**Compliance Audit Report of the
Comptroller and Auditor General of
India
on
Poola Subbaiah Veligonda Project**

Report No. 4 of 2023

**for the year ended March 2021
(Department of Water Resources)**

Line Diagram 2: Stagnation of water due to higher elevation of link canal than Tunnel II

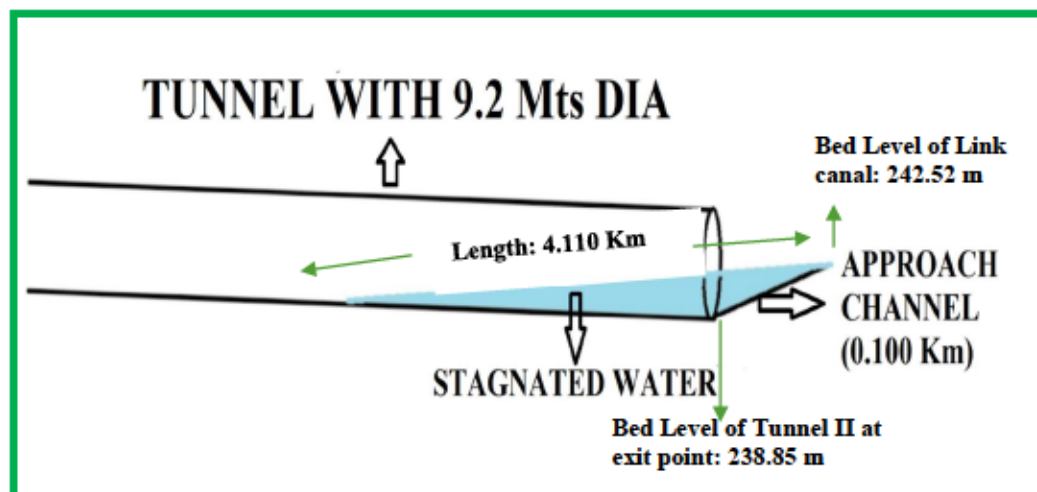
A line diagram (*Not to scale*) is exhibited below to show stagnation of water.

³¹ link canal bed level : 242.52 m, Tunnel II exit point bed level : 238.85 m

The reply is not acceptable, as difference in bed levels would ultimately result in stagnation of water.

Line Diagram 3: Showing the discharges of Tunnels and Feeder Canal

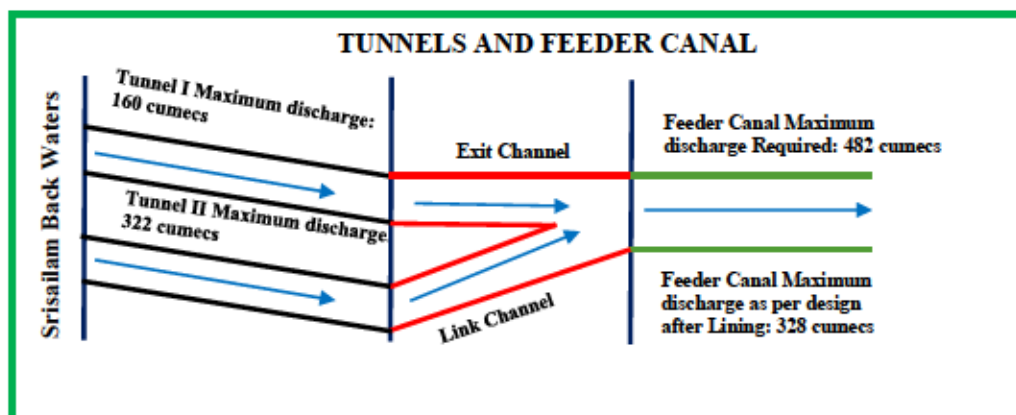
As per approved design, the total quantum of water discharged from both the tunnels should flow into feeder canal through the link canals. The tunnels were designed with a maximum total discharge capacity of 483.32 cumecs (Tunnel I - 160.64 cumecs and Tunnel II - 322.68 cumecs) to draw 43.50 TMC of water in 30 days. As such, feeder canal should have been planned for a discharge capacity of 483.32 cumecs for 30 flood days.

As per calculations made by Audit, without lining, the discharge capacity of feeder canal would be 214.64 cumecs³³ (as detailed in Appendix-I) with a shortfall of 268.67 cumecs (55.19 per cent) of discharge capacity till completion of lining. This would have an adverse effect on drawal of contemplated water and would result in shortage of contemplated ayacut of 1.41 lakh acres³⁴ after completion of lining and 2.42 lakh acres³⁵ without completion of lining. Thus, it is evident that at planning stage, the Department had not designed the capacity of feeder canal in line with the total

discharge capacities of two tunnels. A line diagram (*Not to scale*) is exhibited below to show the difference of discharge capacities.

The Government replied (January 2023) that the feeder canal was designed to carry a discharge of 328 cumecs, duly considering 45 flood days and subsequently the flood days were reduced to 30 days in July 2005. It was further stated that the feeder canal, if required, would be improved to 483 cumecs. The Government admitted the audit observation and stated that the feeder canal would be improved.

Line Diagram 4: Formation of Reservoir with three dams and Link canal

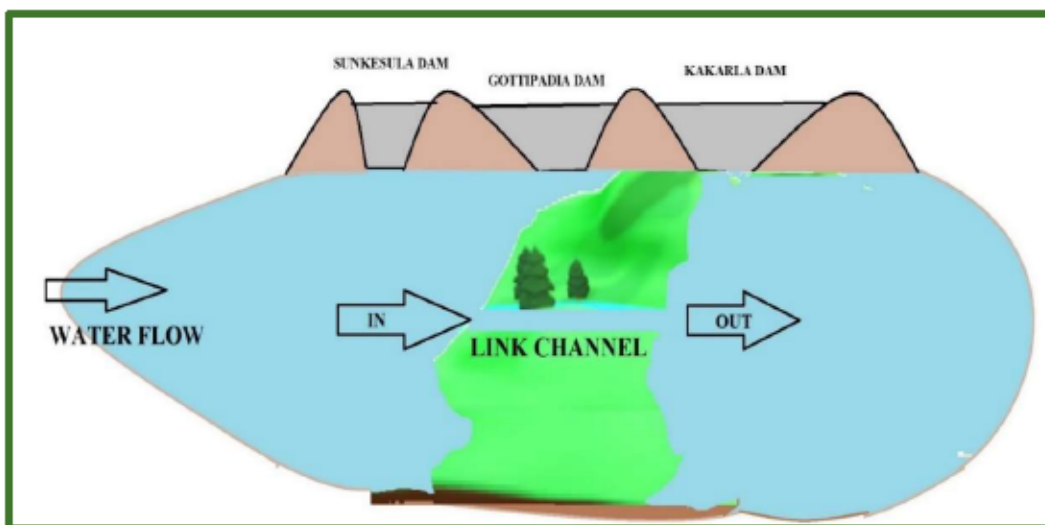
Audit noticed that despite the Department being aware (January 2009) of the elevation of the dams for stage II, no provision was made to construct the saddle dam in the revised estimate. The Nallamallasagar reservoir cannot be filled to its maximum storage capacity unless the saddle dam is constructed.

The reply is not acceptable, as the original ground levels, at the proposed location of saddle dam before formation of road, when compared to FRL of Nallamallasagar reservoir were less by 1.00 to 2.00 m. As such, the necessity to construct saddle dam in this location should have been envisaged at the time of grounding the project. However, the same was identified in August 2019 and final approval of the estimate is still pending.

Line Diagram 7: Showing the adjustment of branch canal between two canals

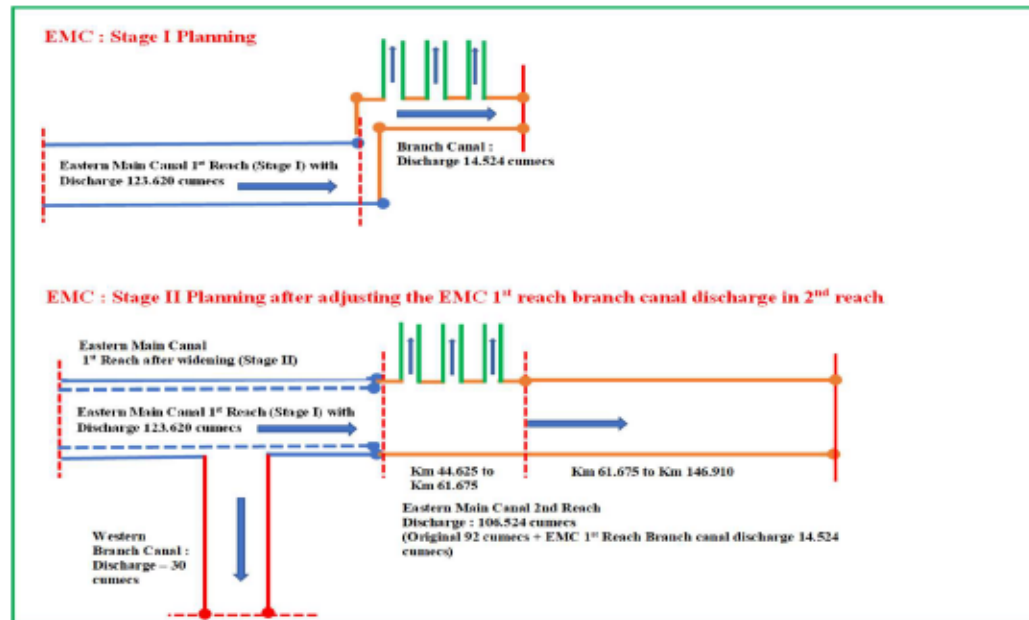
- The Department paid an amount of ₹11.88 crore to the Package IV contractor for the branch canal even though the branch canal was never executed. Since the additional cost involved in widening the EMC second reach was only ₹4.39 crore as per MoU between the two contractors, there was excess payment of ₹7.49 crore (₹11.88 crore - ₹4.39 crore) to the Package IV contractor. Had the Department reviewed the designs while planning for Stage II and deleted the branch canal from Package IV while adding in Package VI, the excess payment could have been avoided.

The reply regarding cost saving of ₹74.63 crore towards land acquisition is not acceptable, as there would be no necessity to acquire the lands for excavation of branch canal, had the department initially planned properly for execution of main canal. As such, it could not be treated as saving. The department allowed to transfer an amount of ₹11.88 crore from distributary network to main canal and paid to the contractor instead of reducing the contract value as branch canal was not executed by the Package IV contractor. Further, there was an additional financial burden of ₹7.85 crore, as accepted by the department towards structures.
